MISSISSIPPI RIVER-GULF OUTLET
LOUISIANA

DESIGN MEMORANDUM NO. 2

GENERAL DESIGN

SUBJECT: Design Memorandum No. 2, General Design, Mississippi River-Gulf Outlet

TABLE 6

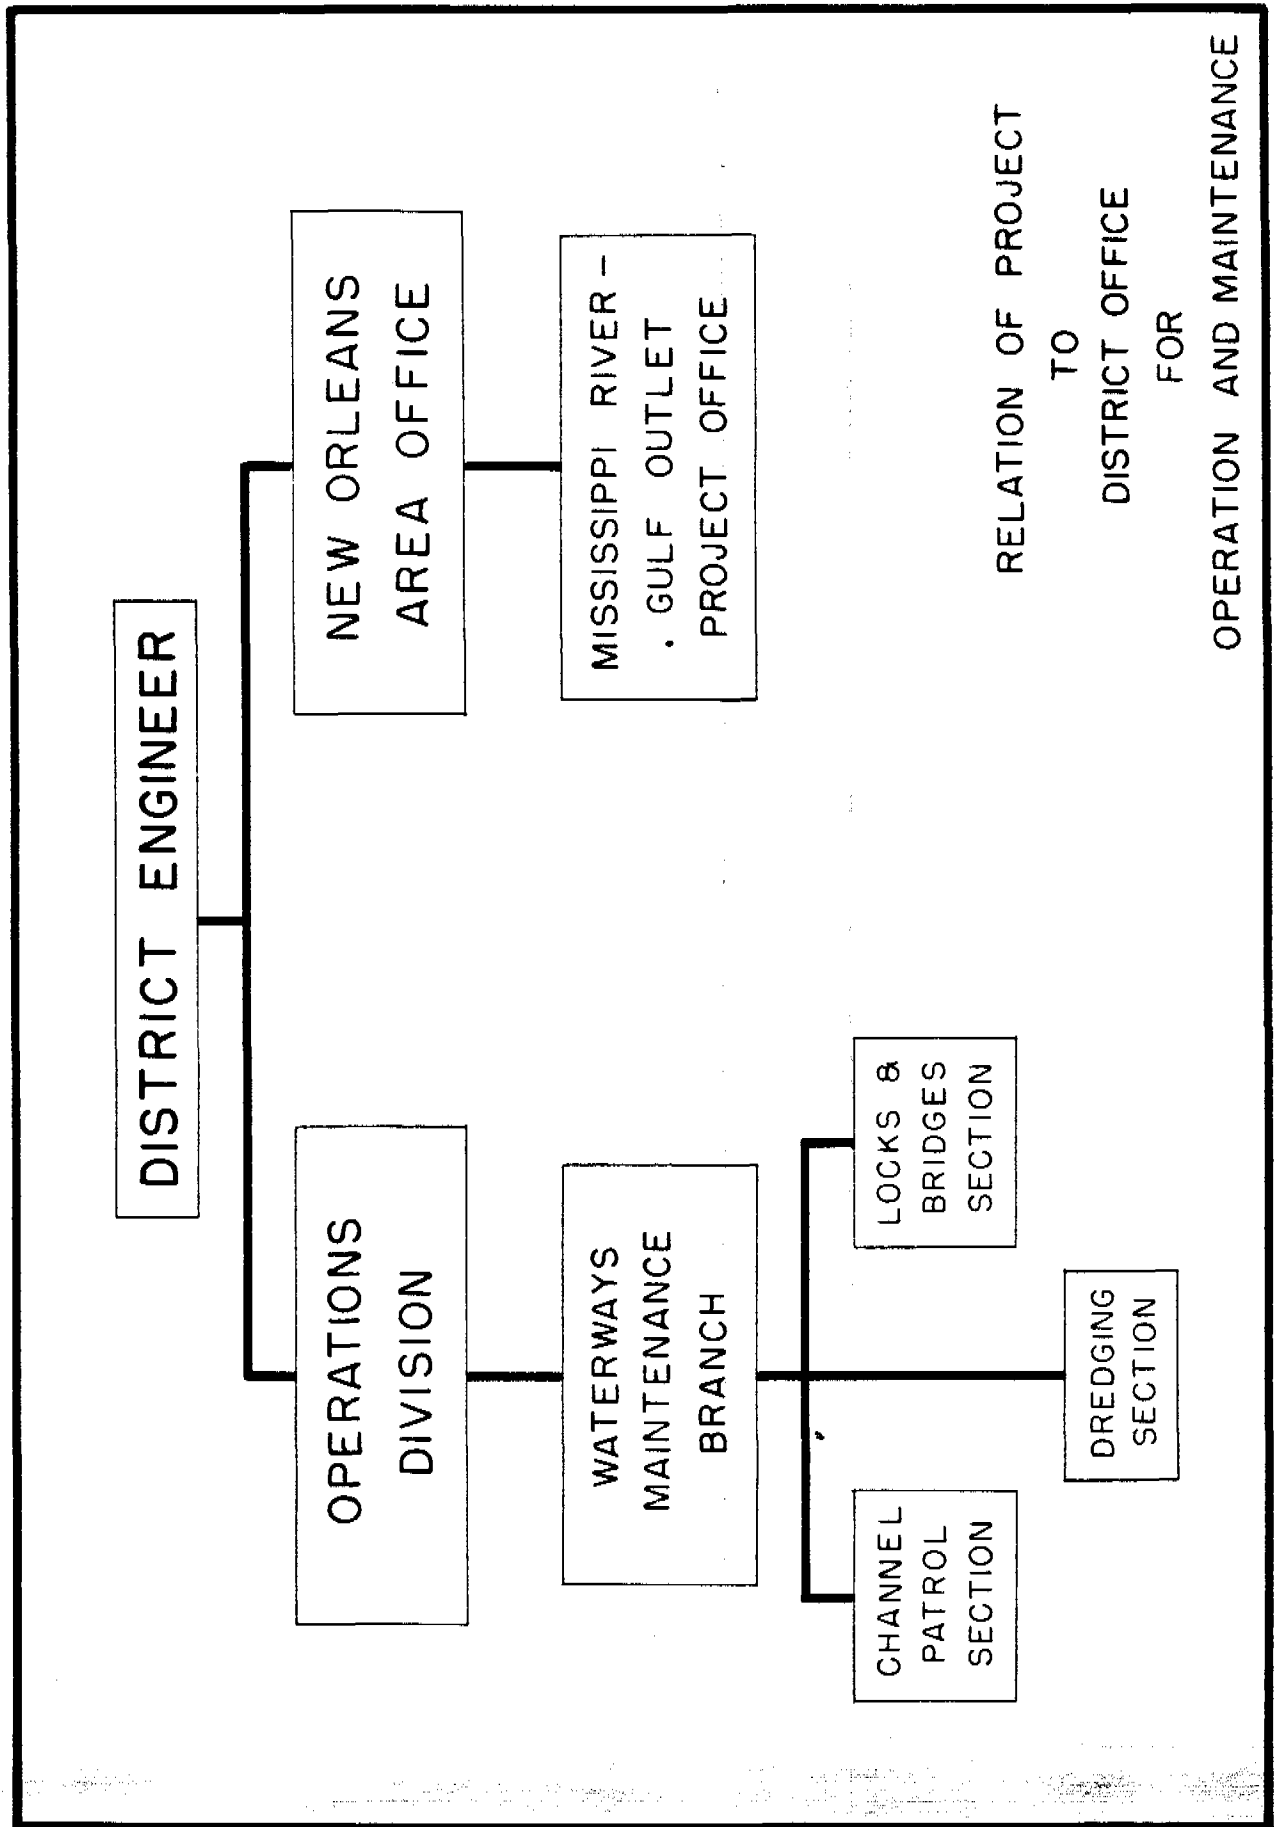
18. Table 6, page 37. Interest during construction includes the interest charges on \$22,346,700 of work deferred until after 1967 (see paragraph 81, page 35). According to the schedule on page 34, the interim channel will be completed by December 1963 and benefits will begin to accrue. Therefore the interest during construction of \$1,396,700 on the deferred work should be excluded thereby reducing the figure of \$6,498,000 to \$4,101,300 and the investment from \$117,615,000 to \$116,218,300. Likewise the annual charges would be reduced from \$5,836,700 to \$5,787,400.

MISSISSIPPI RIVER - GULF OUTLET
LOUISIANA
DESIGN MEMORANDUM NO. 2
LOCATION MAP
ROUTES B, D, E-6, AND ALT. E-6
SCALE AS SHOWN
U. S. ARMY ENGINEER DISTRICT, NEW ORLEANS, LA.
CORPS OF ENGINEERS
JUNE 1959 FILE NO H-2-21517

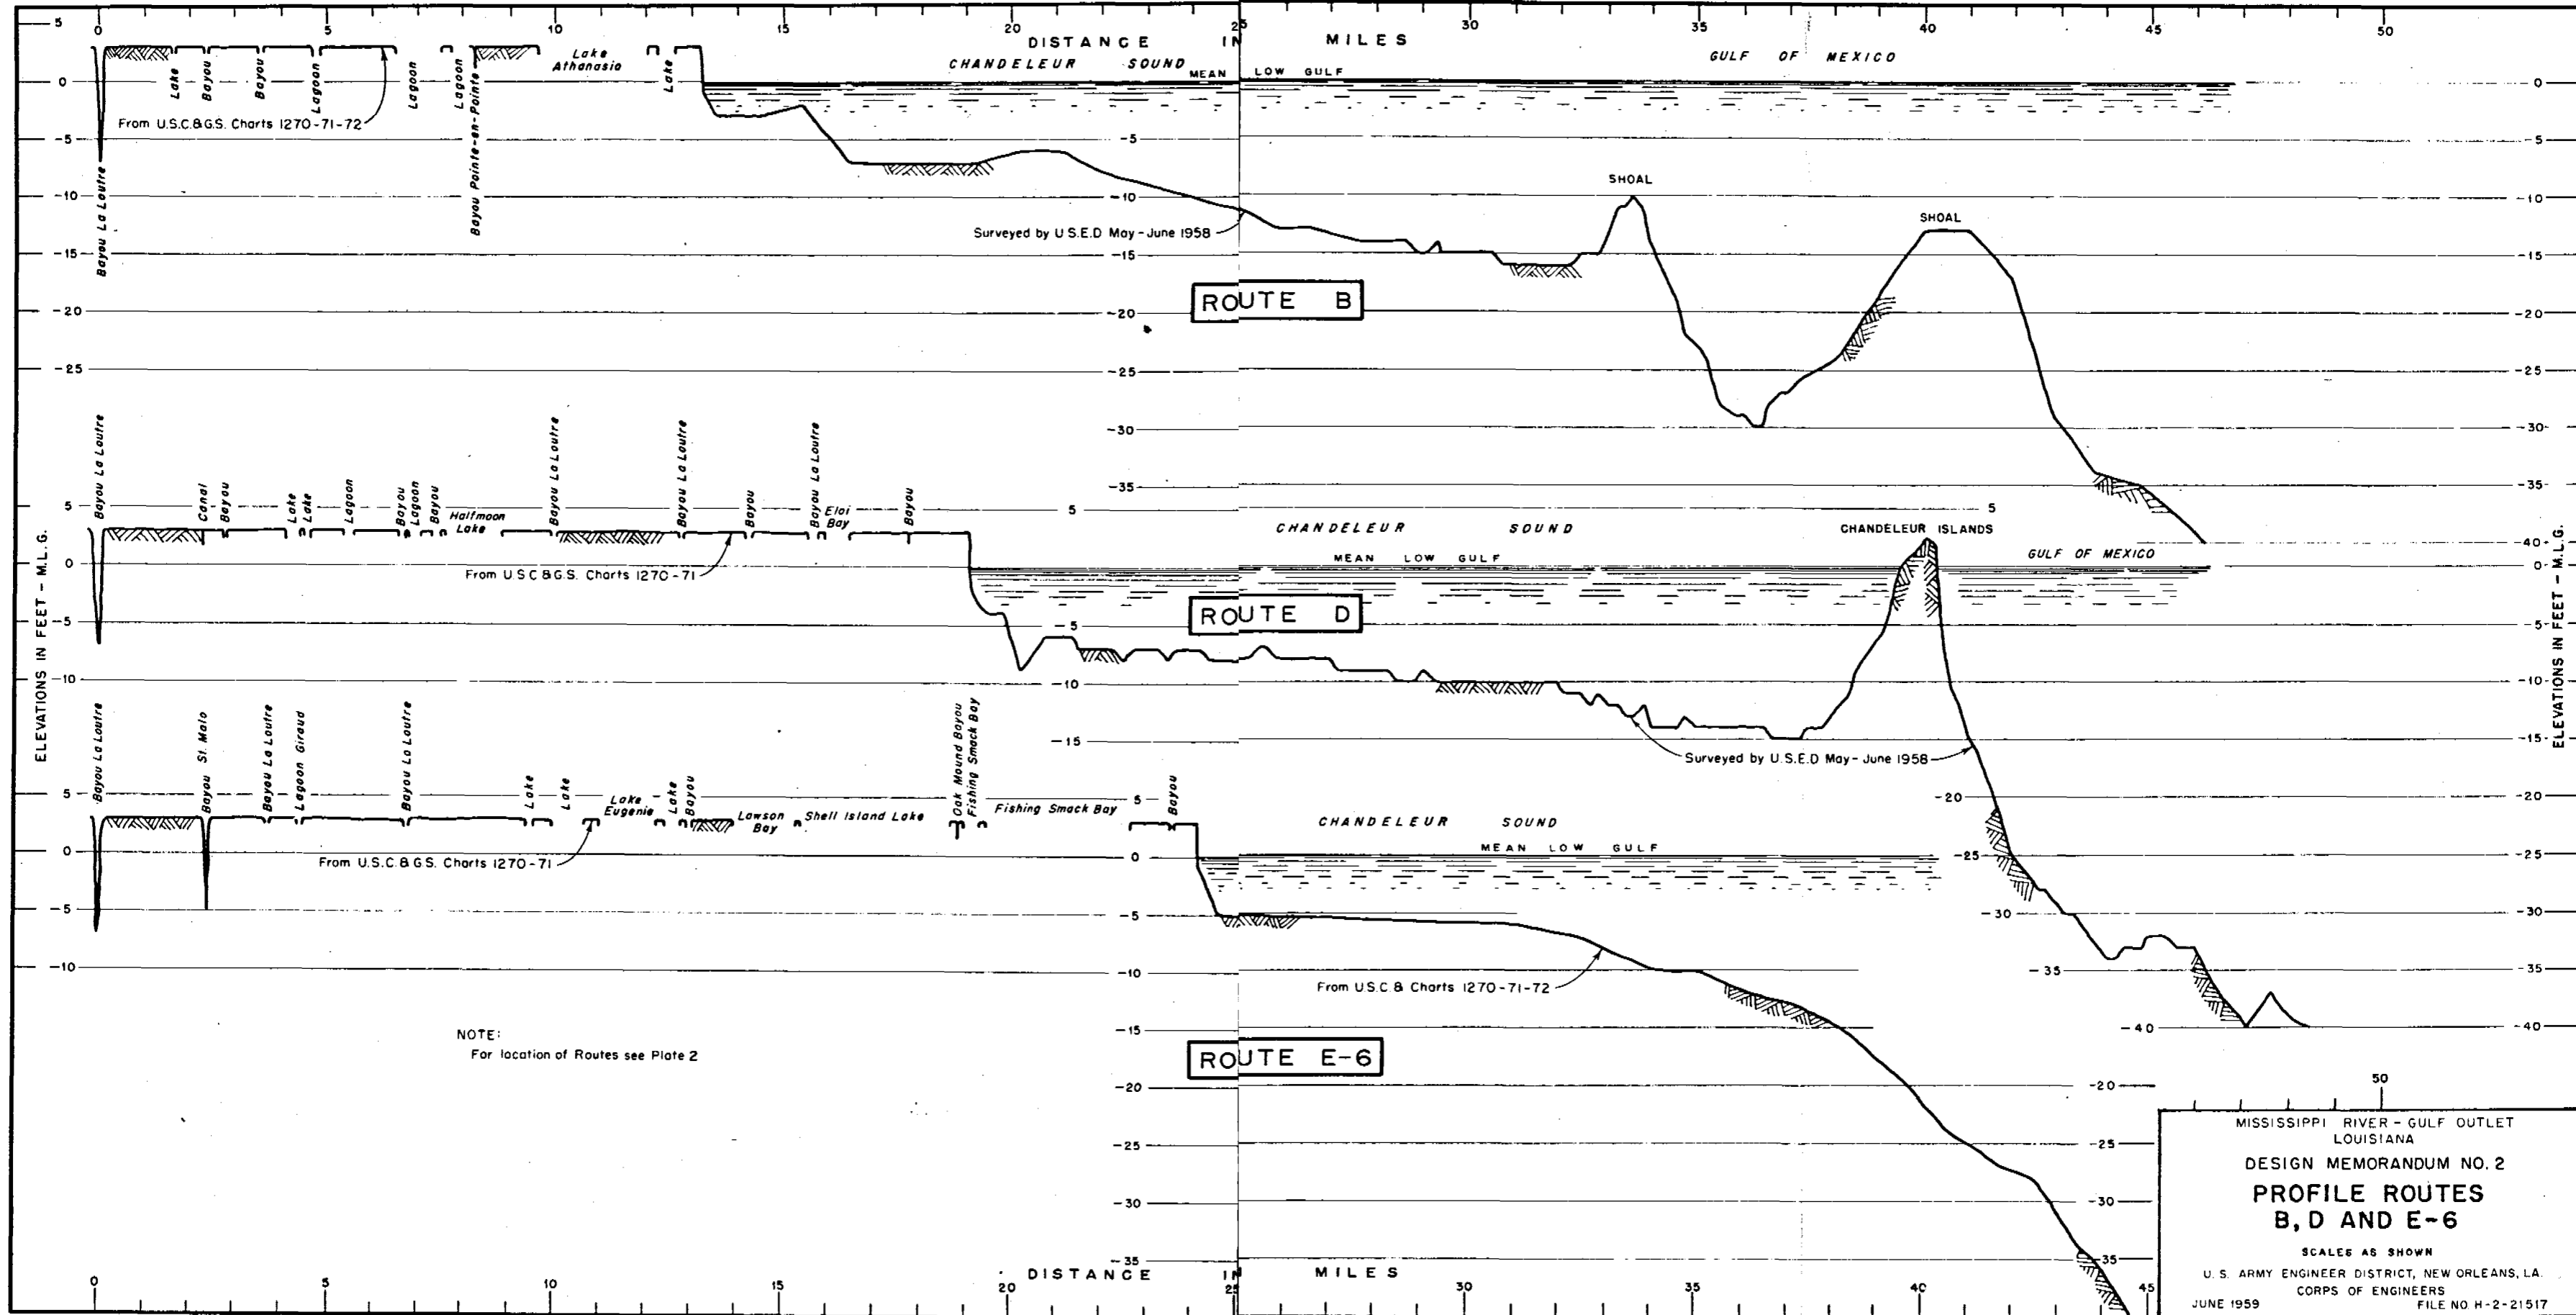
19. Plate 1. Revise the note "Eased Entrance 36 ft x 500 ft to 38 ft x 600 ft" to read "Sea Bar Channel, 38 ft x 600 ft".

MISSISSIPPI RIVER - GULF OUTLET
LOUISIANA
DESIGN MEMORANDUM NO. 2
**TYPICAL SECTIONS
CHANNEL AND DIKES**
U. S. ARMY ENGINEER DISTRICT, NEW ORLEANS, LA.
CORPS OF ENGINEERS
JUNE 1959 FILE NO. H-2-21517

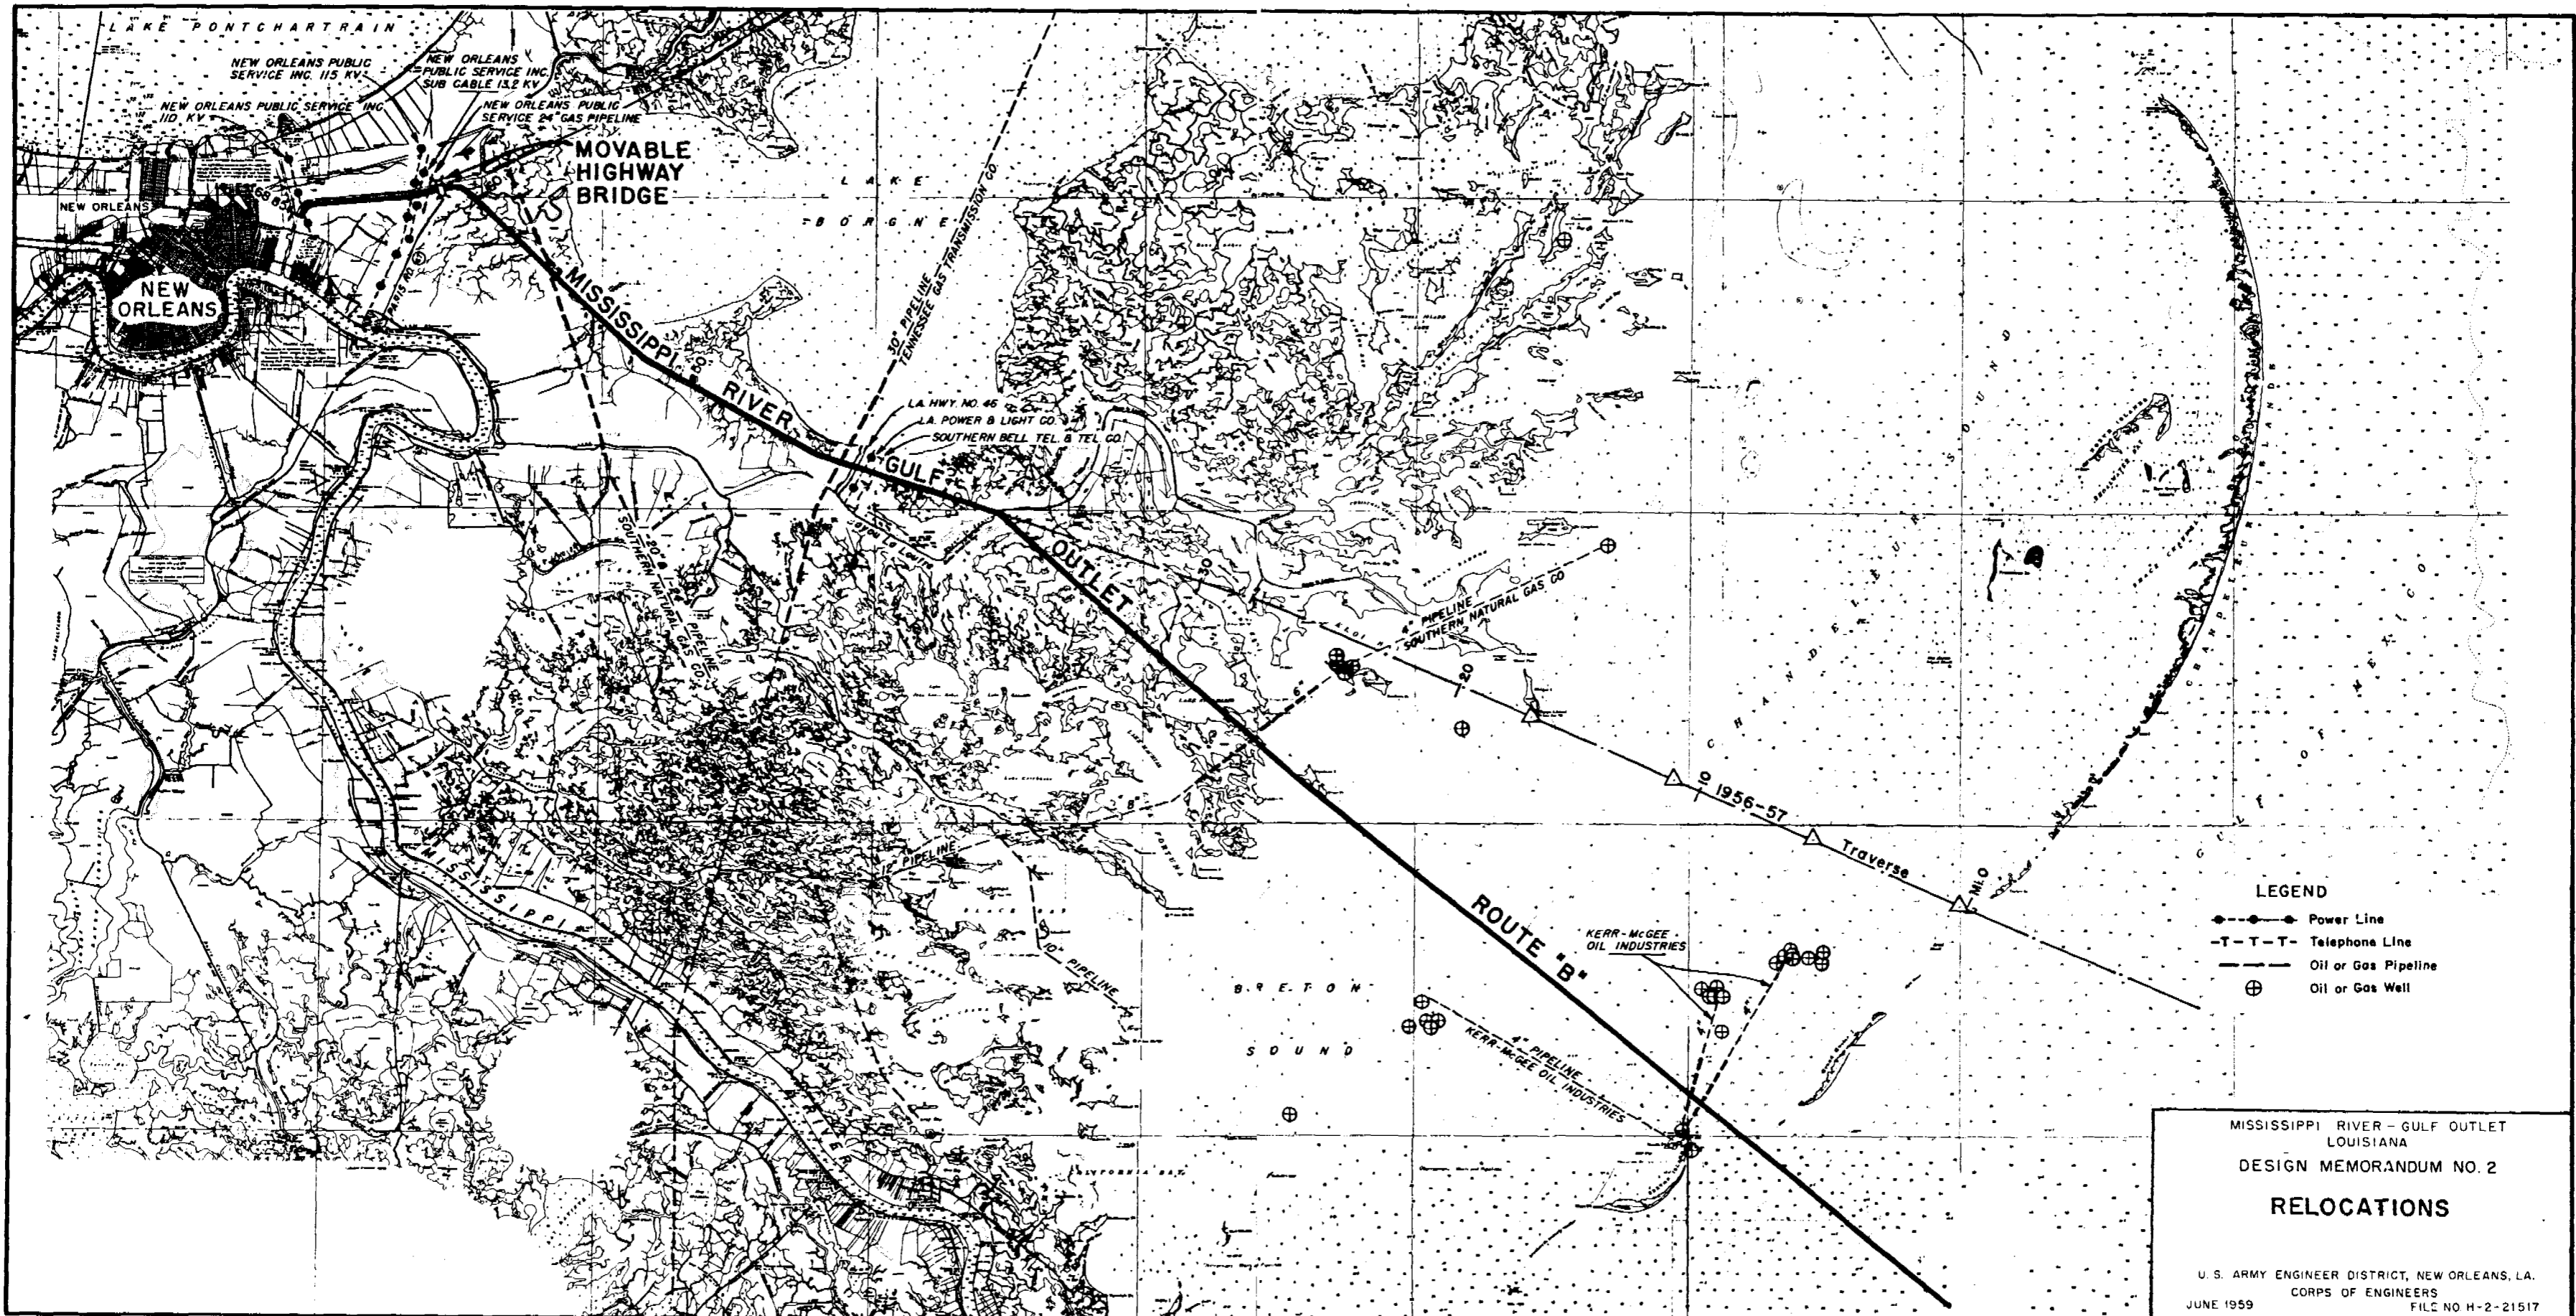
20. Plate 19. a. On the typical section, land cut, mile 63.15 to Chandeleur Sound, change the dimensions from the landside crown of the spoil dike to the borrow area from "not less than 85' " to "not less than 70' ". This will facilitate obtaining dragline equipment capable of constructing the spoil dike.

b. Spoil should be placed in a position which will minimize the tendency for it to migrate back into the channel. This subject which is discussed in paragraphs 32d on page 14, 40 on page 16, 49 on page 22, and 65c on page 25 should be summarized in one paragraph clearly setting forth the proposed plan for spoil disposal.
